SERVICE BULLETIN

Classification: BT22-002	Reference: NTB22-009	Date: February 14, 2022
-----------------------------	-------------------------	----------------------------

DOOR LOCK SERVICE INFORMATION

APPLIED VEHICLES: 2022 Frontier (D41)

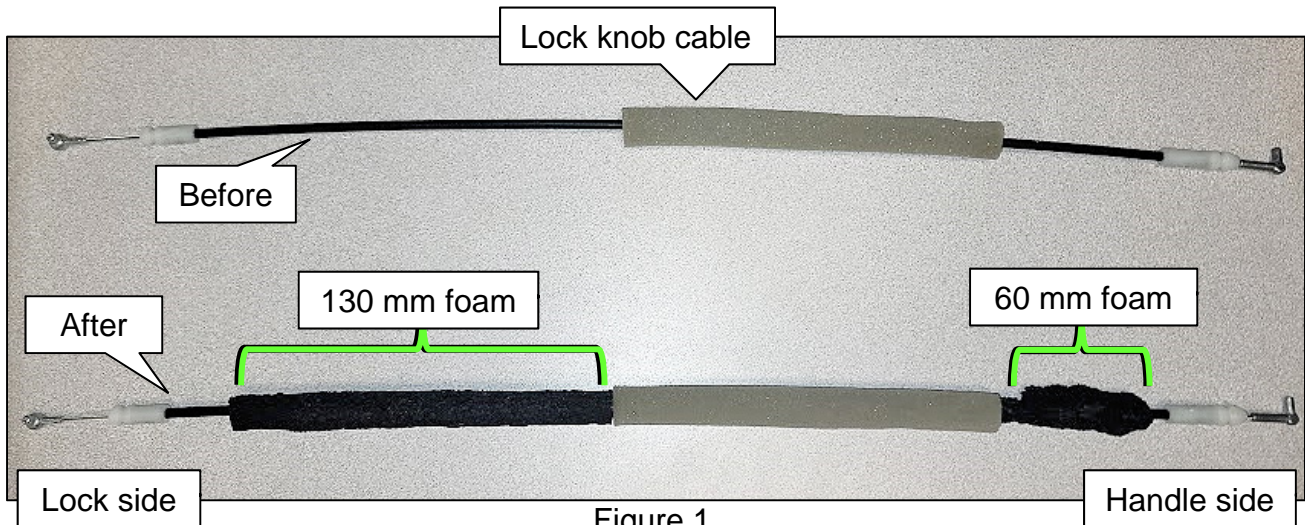
If either the front driver (LH) side or front passenger (RH) side door lock is replaced and does not already have foam applied to the lock knob cable, as shown in Figure 1, self adhesive EPDM semi-closed cell foam (foam) must be applied.

- Apply 130 mm of foam to the lock side
- Apply 60 mm of foam to the handle side
